AMENDMENT "C" UNDER 37 C.F.R. §1.116

APPLICANTS:	Niederdrank et al.	GROUP ART UNIT: 2615
SERIAL NO.:	10/668,855	EXAMINER: Lun S. Lao
FILED:	September 23, 2003	CONFIRMATION NO.: 3145
TITLE:	FEEDBACK COMPENSATION FOR HEARING DEVICES WITH SYSTEM DISTANCE ESTIMATION

FIG 2

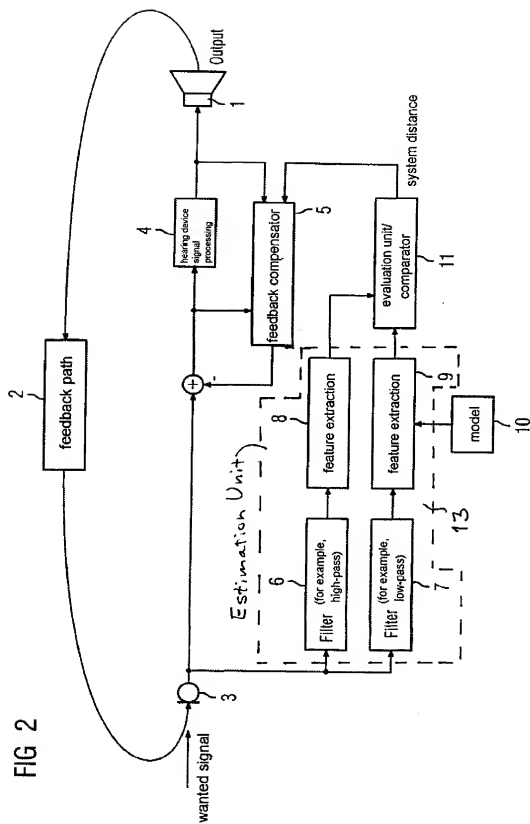
[0016] It is therefore inventively provided to control the operation of the feedback compensator 5 by the embodiment shown according to Figure 2, in the simplest case to connect and disconnect. For control, an estimation unit 13 may be used that estimates the system distance, such that the feedback compensator 5 is first activated given very reduced or negative system distance. The estimation unit comprises a high-pass filter 6 and a low-pass filter 7. These are connected in parallel to the typical signal path between microphone 3 and hearing device signal processing 4, and they separate the output signal of the microphone 3, i.e., the input signal of the hearing device, into a high-frequency portion and a low-frequency portion.

[0017] A feature extraction unit 8 or, respectively, 9 may be respectively connected subsequent to the high-pass filter 6 and the low-pass filter 7 in the estimation unit 13. The features acquired from the feature extraction unit 9 may be associated with model data of a model 10, and the resulting data may then be compared in an evaluation unit 11 with the data of the feature extraction unit 8. The comparison result is a measurement of the system distance, with which the feedback compensator 5 is controlled.

In the October 14, 2008 Office Action, the drawings were objected to under 37 C.F.R. §1.83(a) because the Examiner stated the drawings must show the estimation that is connected between the input device and the feedback reduction device. As explained in the specification as originally filed, the estimation unit includes the two filters 6 and 7 and the two feature extractors 8 and 9. Such an estimation unit has therefore been indicated in dashed lines in each of Figures 2, 3, 4, 5 and 6, and the written portion of the specification has been editorially amended to identify the estimation unit with reference numeral 13. Since the estimation unit is clearly identified in the specification as originally filed, no new matter is added thereby.

Each of Figures, 2, 3, 4, 5 and 6 has been amended as shown on the replacement sheets attached hereto.
